HISTORIC AND DESIGN REVIEW COMMISSION

June 05, 2019

HDRC CASE NO: 2019-315
ADDRESS: 310 CALLAGHAN AVE
LEGAL DESCRIPTION: NCB 721 BLK 3 LOT N 80.04 FT OF 3
ZONING: RM-4
CITY COUNCIL DIST.: 1
DISTRICT: Lavaca Historic District
APPLICANT: Justin Ferdinand/Alamo Wealth Builders, LLC.
OWNER: Justin Ferdinand/Alamo Wealth Builders, LLC.
TYPE OF WORK: Exterior modifications
APPLICATION RECEIVED: May 17, 2019
60-DAY REVIEW: July 16, 2019
CASE MANAGER: Huy Pham

SITE PLAN

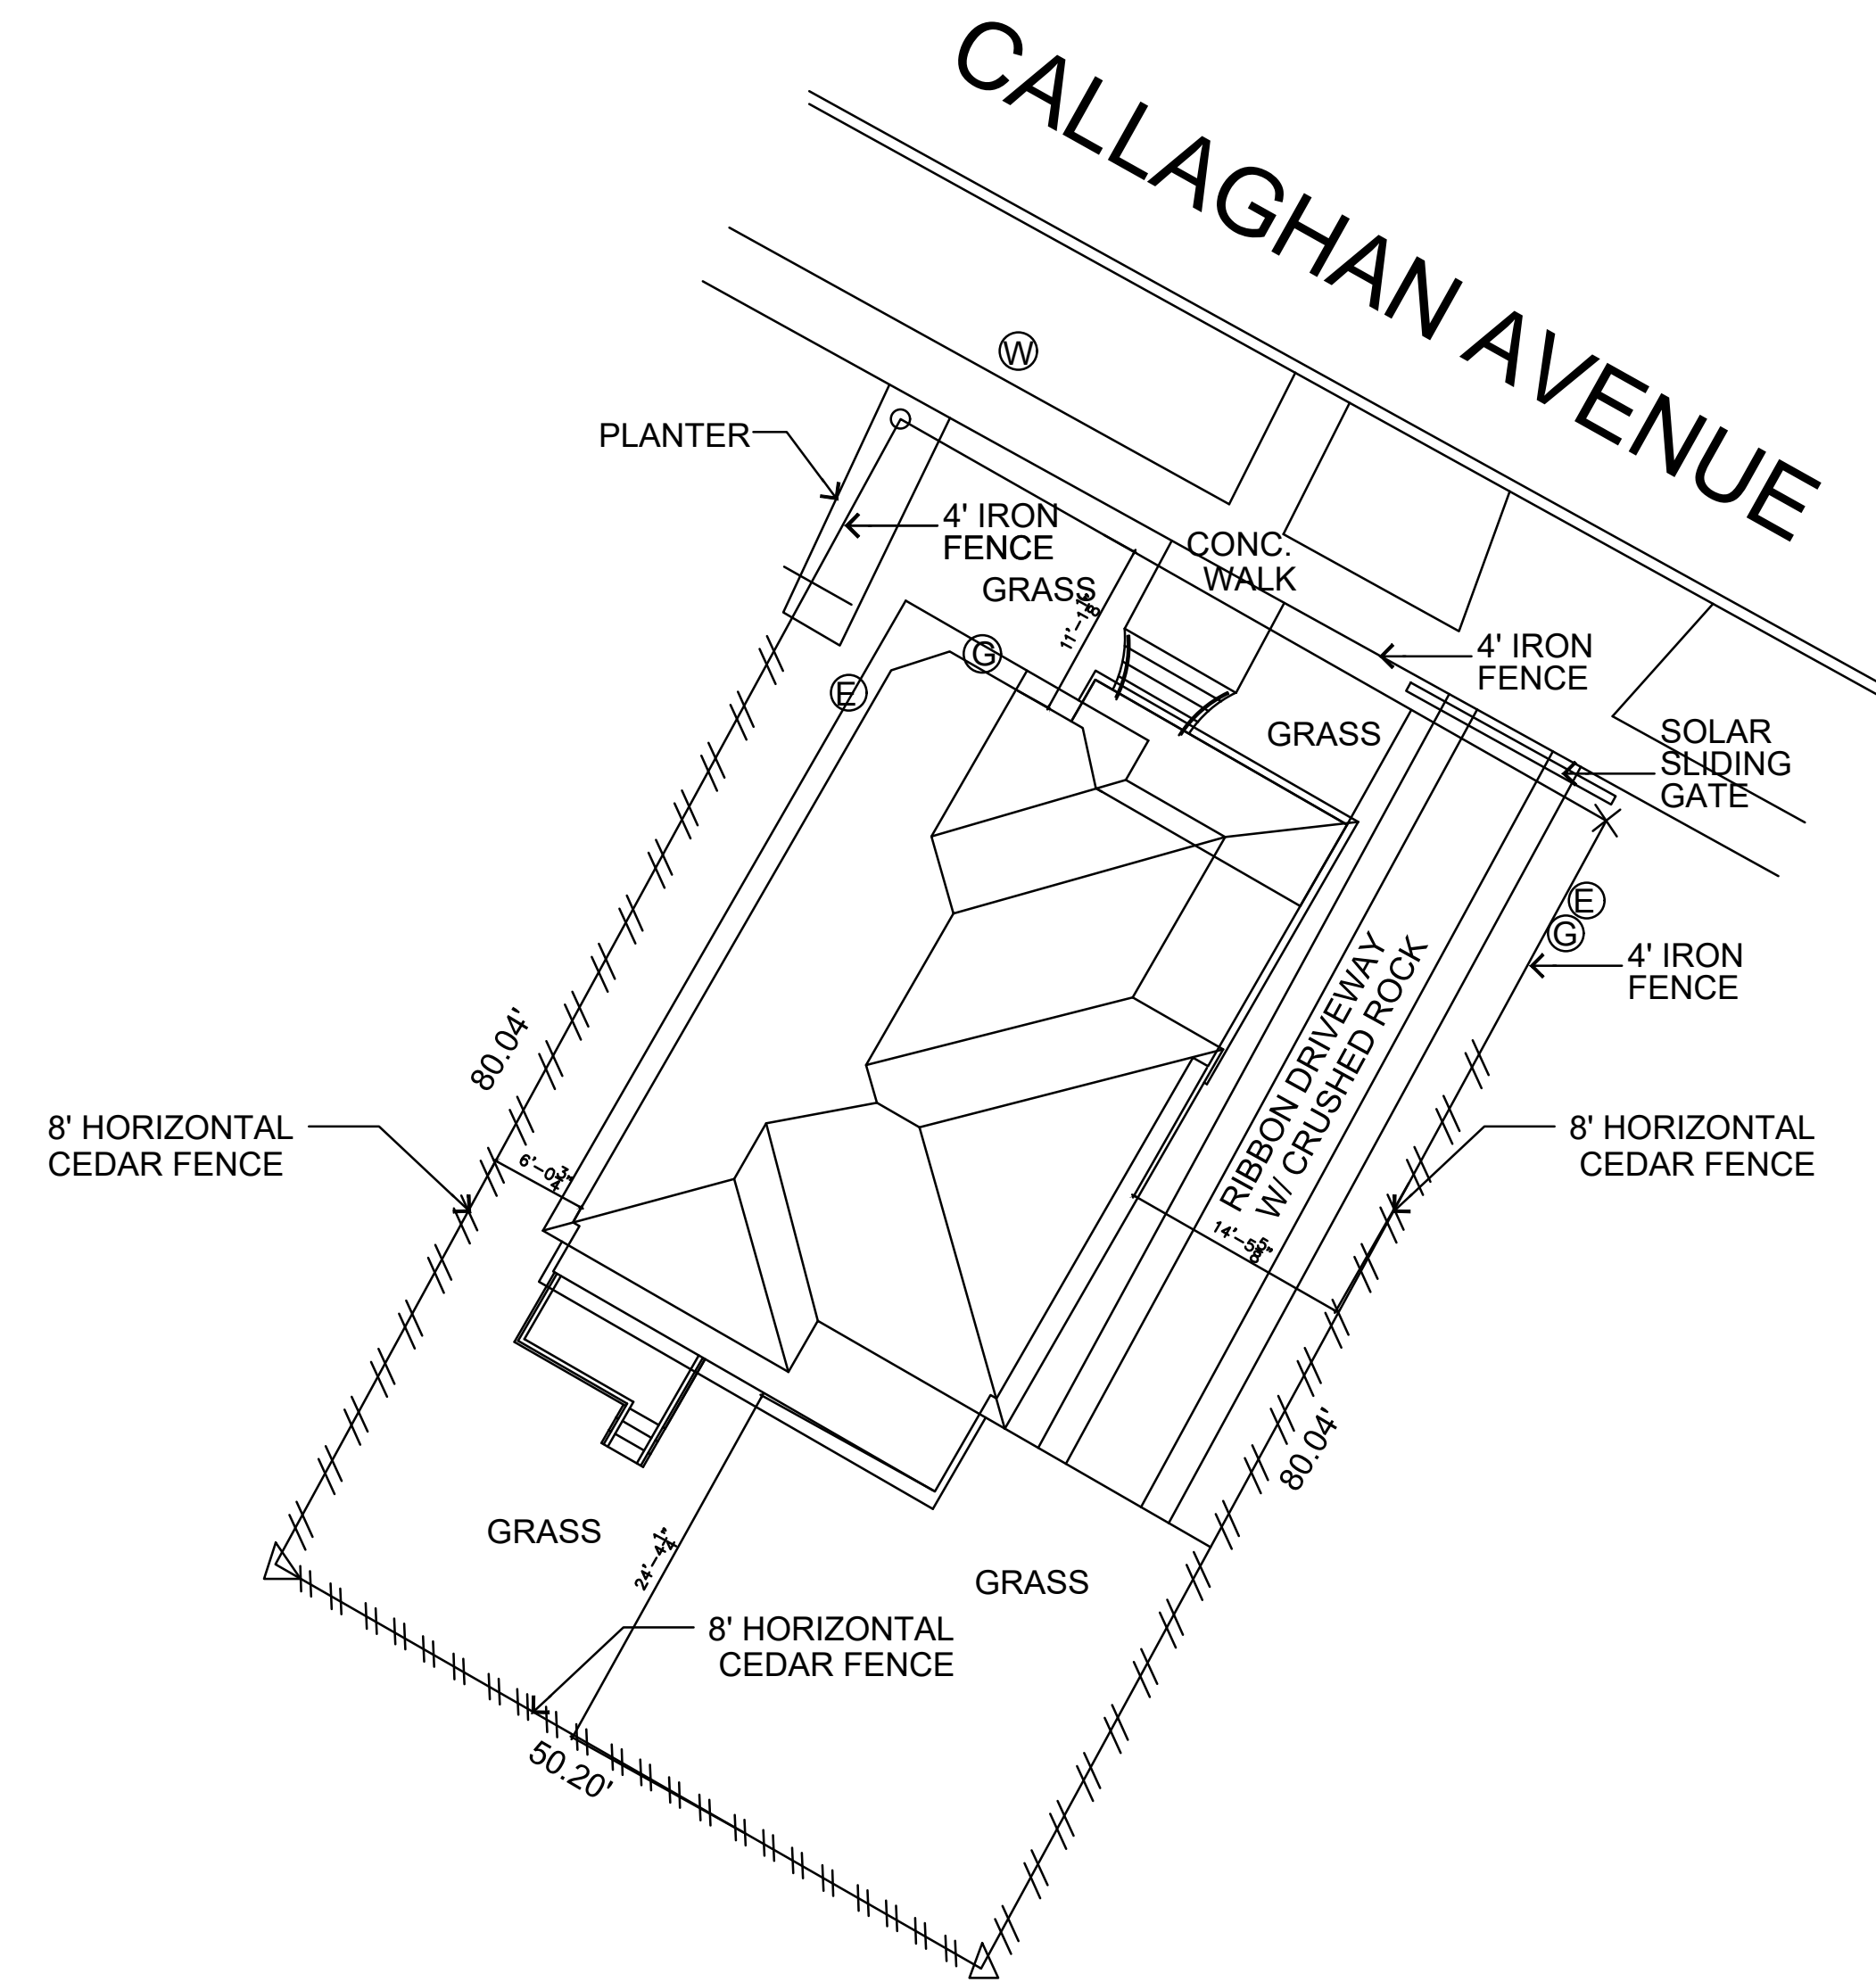
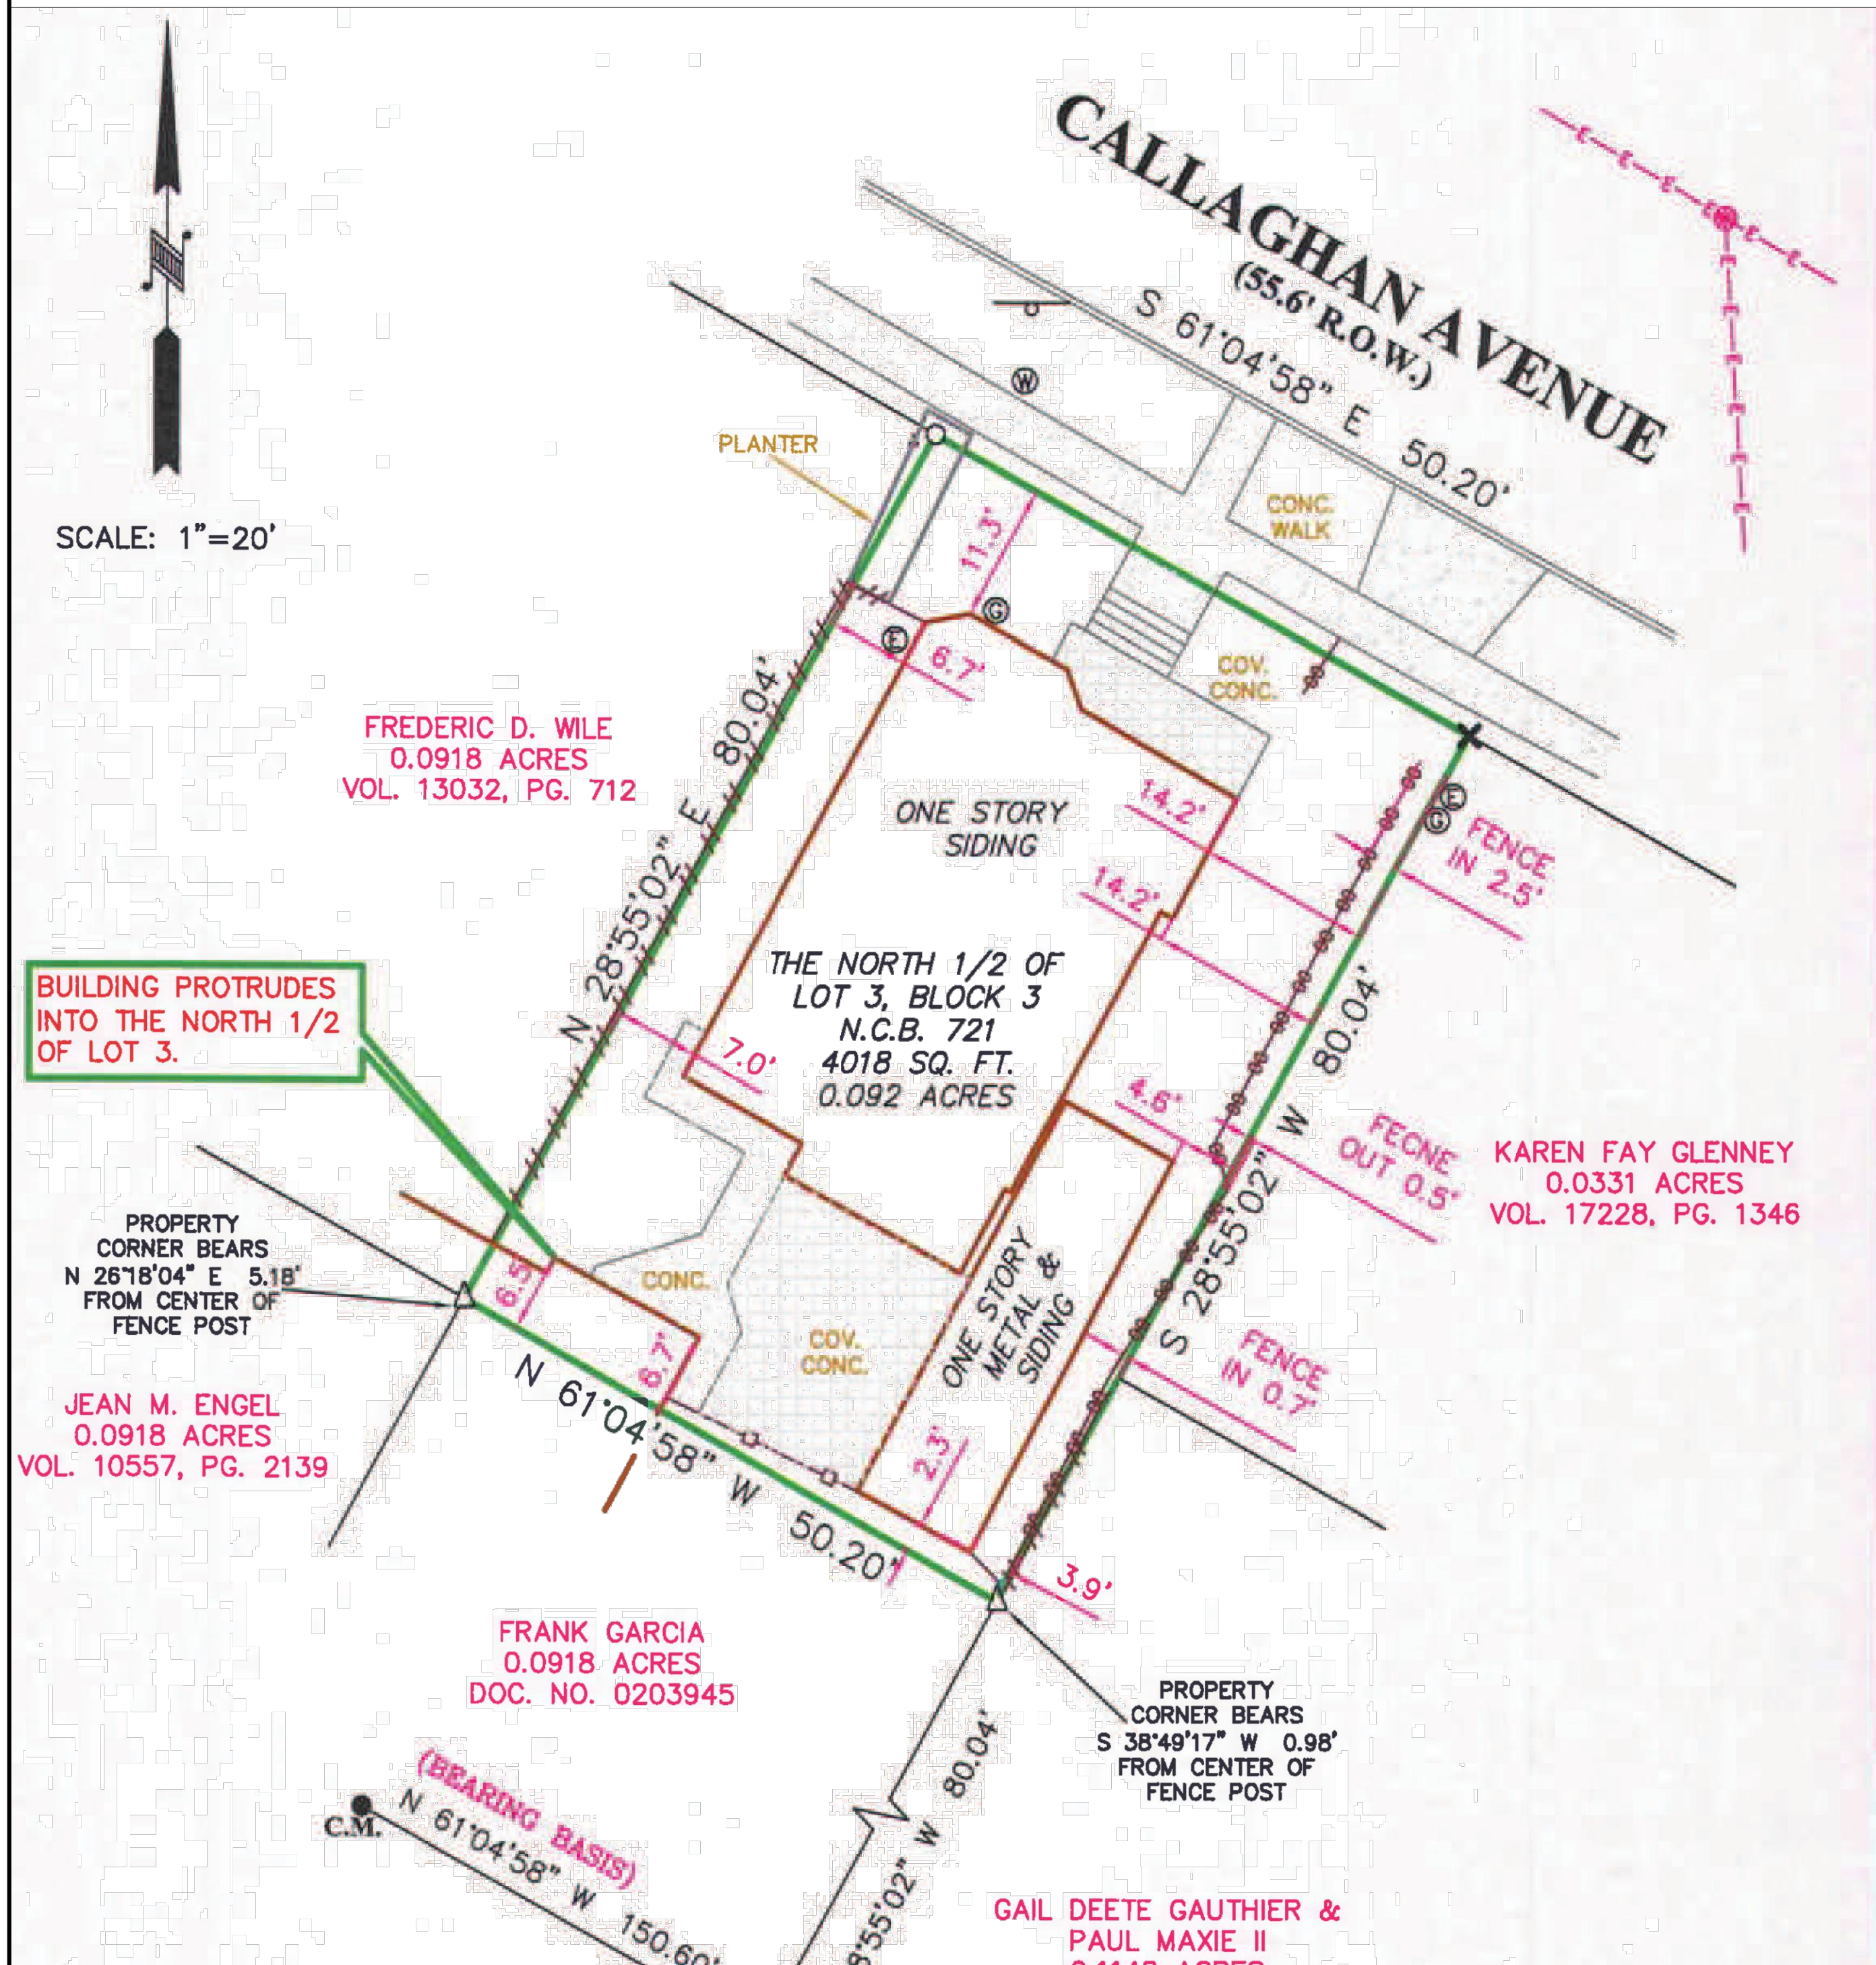
- k. FRONT YARD FENCE – The applicant has proposed to install a four-foot (4') tall wrought iron fence in the front yard including a solid horizontal sliding wood gate with solar panel across the front of the driveway. Staff finds that front yard fences are found on the block and within the Lavaca Historic District and that wrought iron fences are appropriate for Folk Victorian style houses. However, per the Guidelines for Site Elements 5.2.C.ii. privacy fences should not be used in the front yard. Staff finds that the wrought fence should turn at the corner of the front yard and return at the corner of the historic structure instead of spanning across the driveway, and that the solid horizontal wood gate should be set behind the front façade plane of the primary historic structure or be excluded from the design.

- l. REAR YARD FENCE – The applicant has proposed to install an eight-foot (8') tall solid horizontal wood privacy fence at the rear of the property. A six-foot (6') tall wood privacy fences set behind the front façade plane of the historic structure is eligible for administrative approval. Staff finds that the proposed height is inconsistent the Historic Design Guidelines and the Unified Development Code Sec 35-514.

- m. RIBBON DRIVEWAY – The applicant has proposed to install a concrete ribbon driveway with crushed rocks in between the ribbon. The driveway is currently not paved and ribbon driveways are present on the block and within the Lavaca Historic District. Per the Guidelines for Site Elements 5.5.B.i., a similar driveway configuration—materials, width, and design—to that historically found should be incorporated on the site; historic driveways are typically no wider than 10 feet and pervious paving surfaces may be considered where replacement is necessary to increase storm water infiltration. Staff finds that the proposed ribbon driveway and pervious cover is generally appropriate;

remove right front door and repair with existing D117 Siding	Requires HDRC hearing	Elevation drawing of front façade (see A2.0/1 & Image E, H)
remove vinyl siding and repair 3" overlap siding (Repeated)	May be eligible for admin, need to verify scope	Photo of exposed wood siding under current vinyl siding, rotten wood should be replaced with matching profile
move left door to the right 12" and replace w existing wood door	Requires HDRC hearing	Elevation drawing of front porch, drawing or example photo of proposed new door. If removing historic door, needs to match. (see A2.0/1 & Image J, K)
repair 6' fence to the right with horizontal cedar	May be eligible for admin if rear fence only	Site plan with fence line (see A0.2/1)
demo dilapidated stand alone carport, demo shed on shared property	separate pending request by applicant Cameron Baker	
Continue fence build 8' ft fence on rear of property, 8' fence on rear dividing property lines would equate to 6' of privacy since house sits 2' above ground on pier and beam as permitted in city code, bringing enhanced value to the neighborhood to give proper privacy from neighbors.	Requires HDRC hearing, limit 6' in rear and 4' in front	Site plan with fence line (see A0.2/1 & Image L)

- vi. The front yard fence turns at the corner of the yard and returns to the corner of the house rather than span across the driveway; the gate should be located behind the front façade plane of the house or removed from the design; no portion of the front yard fence is to exceed four-feet (4') in height.

- vii. No portion of the rear privacy fence is to exceed six-feet (6') in height/
- viii. The ribbon driveway is to feature concrete ribbons no wider than two-feet (2') with a total width no wider than ten-feet (10').
